SUBJECT: WATERFORD STEAM ELECTRIC STATION, UNIT 3 - STAFF ASSESSMENT OF INFORMATION PROVIDED PURSUANT TO TITLE 10 OF THE *CODE OF FEDERAL REGULATIONS* PART 50, SECTION 50.54(f), SEISMIC HAZARD REEVALUATIONS FOR RECOMMENDATION 2.1 OF THE NEAR-TERM TASK FORCE REVIEW OF INSIGHTS FROM THE FUKUSHIMA DAI-ICHI ACCIDENT (TAC NO. MF3712)

STAFF ASSESSMENT BY THE OFFICE OF NUCLEAR REACTOR REGULATION

RELATED TO SEISMIC HAZARD AND SCREENING REPORT

WATERFORD STEAM ELECTRIC STATION, UNIT 3

Figure 3.3-1 Plot of Staff's and Licensee's Base Case Shear-Wave Velocity Profiles for the Waterford Site

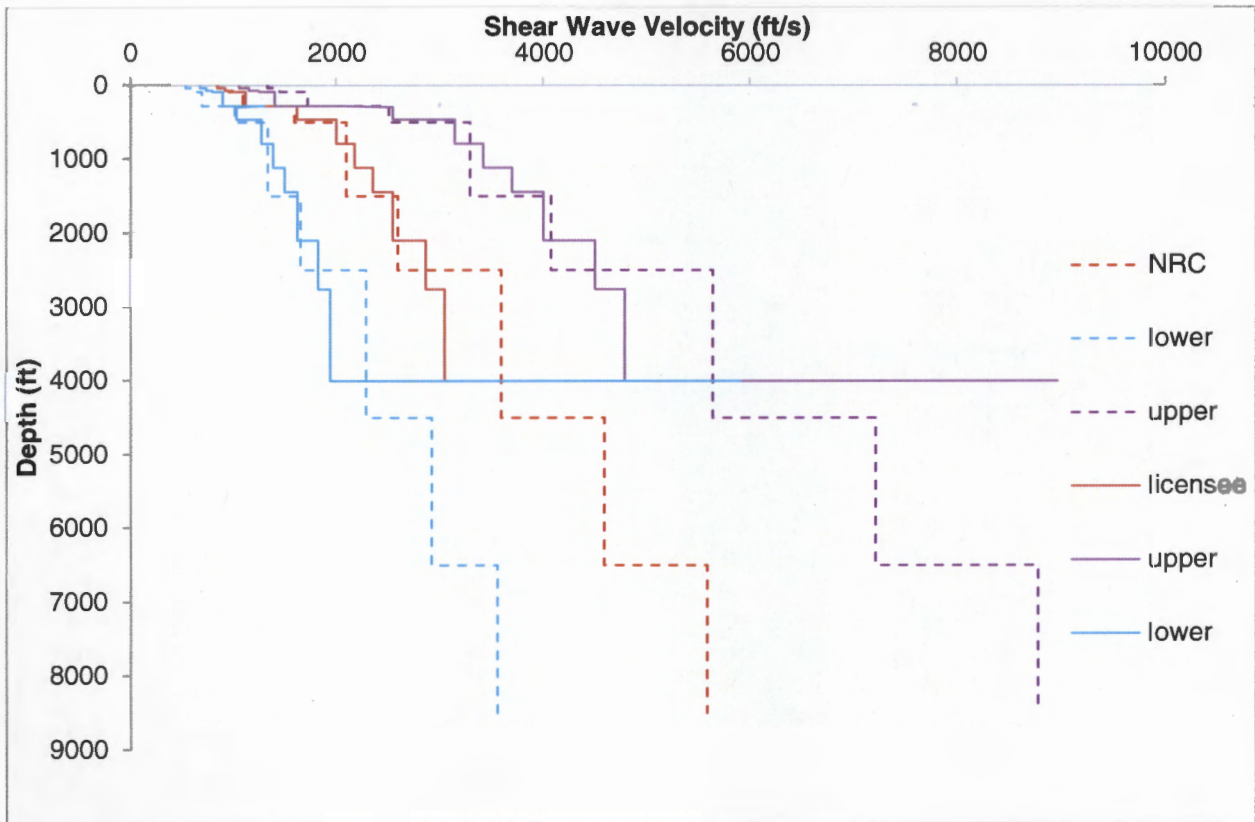
The licensee developed three base case shear-wave velocity profiles for the Waterford site using shear-wave velocities determined from in-situ shear and compressional wave velocity measurements of the uppermost 173 ft. (53 m) of the subsurface. The licensee extrapolated these values to a depth of 515 ft. (157 m) using geologic information available at the site. Below this depth, the licensee used a template profile from the SPID to extend the best-estimate base case profile to a depth of 4,000 ft. (1,219 m). The licensee stated that velocity variations at depths greater than 4,000 ft. (1,219 m) are expected to have little impact on the site response at frequencies below the 0.5 Hz minimum defined by the GMM. The licensee calculated lower and upper base case shear-wave velocity profiles using a scale factor of 1.25 over the upper 173 ft. (53 m) and a factor of 1.57 below. These scale factors are consistent with a natural log standard deviation of 0.2 and 0.35 for the upper and lower portions of the profiles respectively. Figure 3.3-1 of this assessment shows the licensee's three base case shear-wave velocity profiles.

Geotechnical investigations performed during initial licensing include, refraction surveys, up-hole and cross-hole surveys, and cyclic triaxial testing of the shallow subsurface. The NRC staff relied on this in-situ data to develop its base case shear wave velocity profile to the depth of approximately 400 ft. (122 m). The NRC staff extended its profile to a depth of 8,000 ft. (2,438 m) using the velocity gradient recommended in the SPID. To account for uncertainty in the shear wave velocity, the NRC staff used a natural log standard deviation of 0.2 to calculate upper and lower base case profiles. Figure 3.3-1 of this assessment shows a comparison of the three base case velocity profiles developed by the licensee with those developed by the NRC staff. Profiles developed by the licensee are similar in shape to those developed by the NRC staff; however, the profiles developed by the NRC staff extend to a greater depth and have higher velocities at depths greater than approximately 2,500 ft. (762 m).

Figure 3.3-2 Plot Comparing the Staff's and the Licensee's Median Amplification Functions and Uncertainties for the Waterford site.

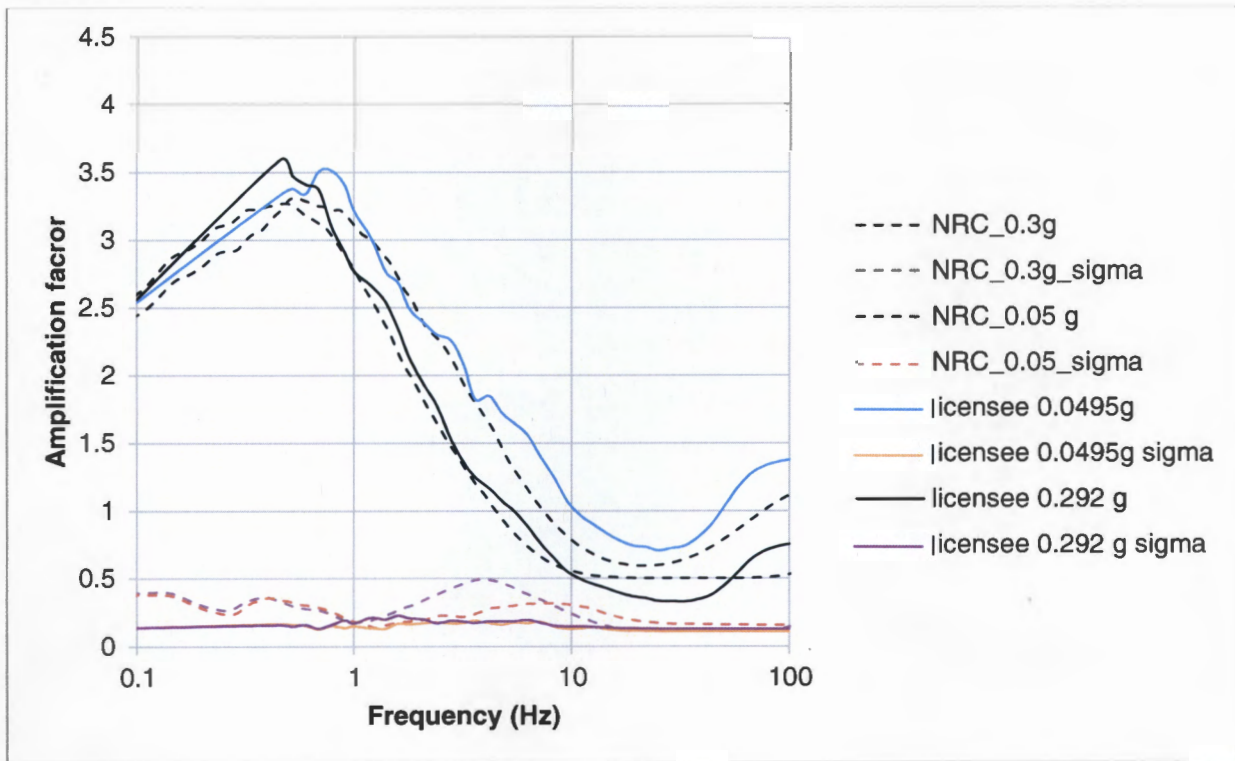
Figure 3.3-2 of this assessment shows a comparison of the staff's and the licensee's median site amplification functions and uncertainties (± 1 standard deviation) for two of the eleven input loading levels. Overall, the staff's and the licensee's site amplification functions are consistent, with a peak at approximately 5 Hz. Minor differences in site amplification functions are due primarily to difference in the staff's and licensee's site velocity profiles. As shown in Figure 3.3- 3 of this assessment, these differences in site response have only a minor impact on the control point seismic hazard curves and the resulting GMRS, discussed below. Appendix B of the SPID provides guidance for performing site response analyses, including capturing the uncertainty for sites with less subsurface data. However, the guidance is neither entirely prescriptive nor comprehensive. As such, various approaches in performing site response analyses, including the modeling of uncertainty, are acceptable for the 50.54(f) response.

Figure 3.3-3 Plot Comparing the Staff's and the Licensee's Mean Control Point Hazard Curves at a Variety of Frequencies for the Waterford site

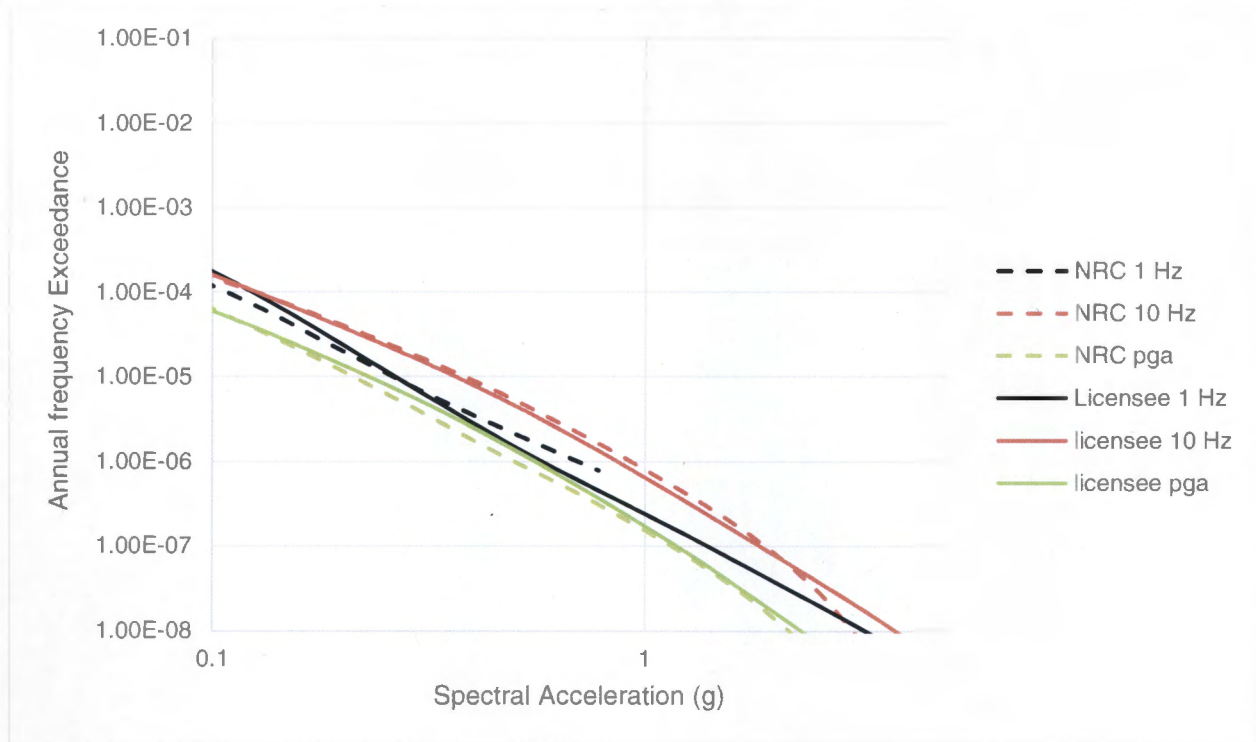
In summary, the NRC staff concludes that the licensee's site response was conducted using present-day guidance and methodology, including the NRC-endorsed SPID. The NRC staff performed independent calculations to confirm that the licensee's amplification factors and control point hazard curves adequately characterize the site response, including the uncertainty associated with the subsurface material properties, for the Waterford site.

Figure 3.4-1 Comparison of the Staff's GMRS with Licensee's GMRS and the SSE for the Waterford site

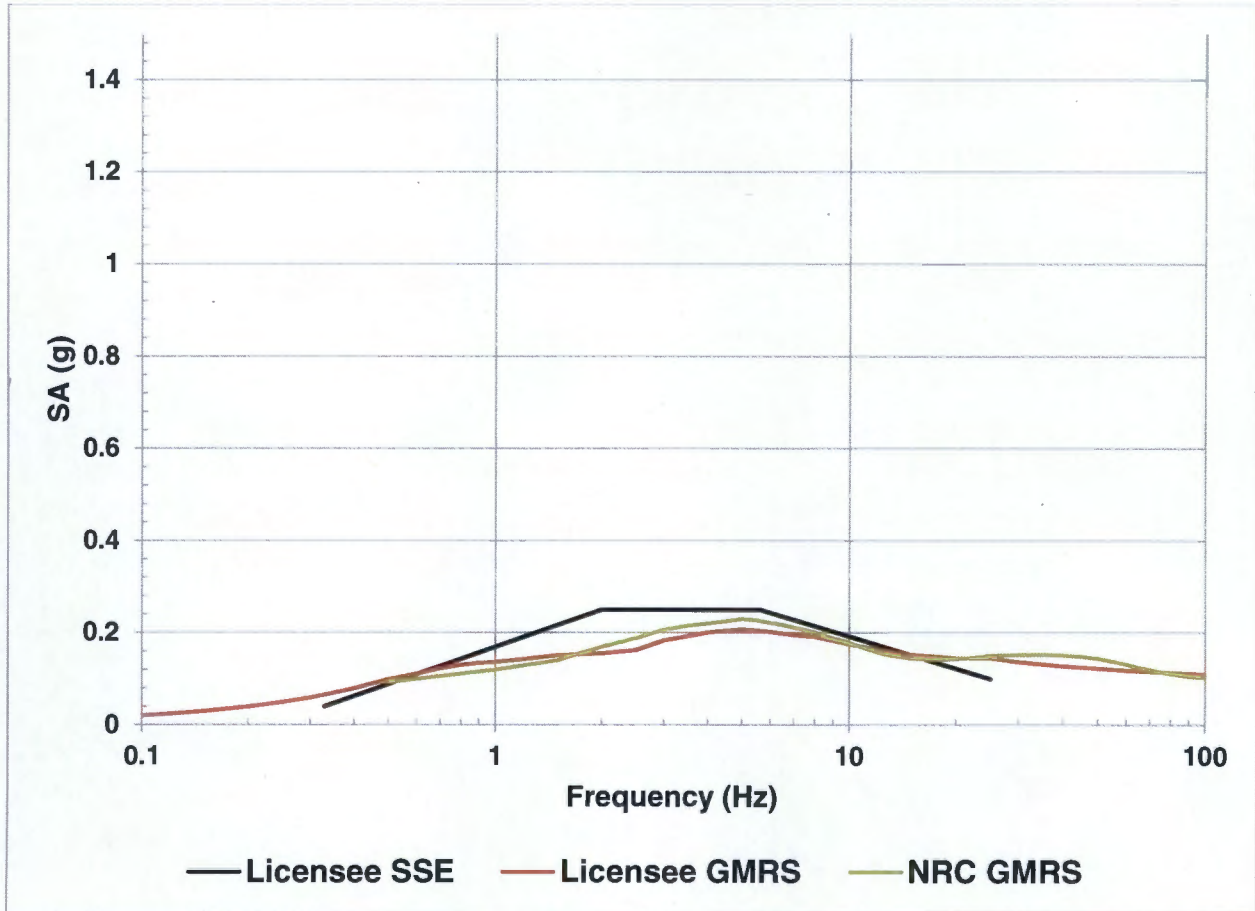
In Section 2.4 of its SHSR, the licensee stated that it used the control point hazard curves, described in SHSR Section 2.3.7, to develop the 10^{-4} and 10^{-5} (mean annual frequency of exceedance) uniform hazard response spectra (UHRS) and then computed the GMRS using the criteria in RG 1.208. The NRC staff independently calculated the 10^{-4} and 10^{-5} UHRS using the results of its confirmatory PSHA and site response analysis, as described in Sections 3.2 and 3.3 of this staff assessment, respectively. Figure 3.4-1 of this assessment shows a comparison of the GMRS determined by the licensee to that determined by the NRC staff. As shown in Figure 3.4-1, the licensee's GMRS shape is very similar to that calculated by the NRC staff.

The staff confirms that the licensee used the present-day guidance and methodology outlined in RG 1.208 and the SPID to calculate the horizontal GMRS, as requested in the 50.54(f) letter. The staff performed both a PSHA and site response confirmatory analysis and achieved results consistent with the licensee's horizontal GMRS. As such, the NRC staff concludes that the GMRS determined by the licensee adequately characterizes the reevaluated hazard for the Waterford site. Therefore, this GMRS is suitable for use in subsequent evaluations and confirmations, as needed, for the licensee's response to the 50.54(f) letter.
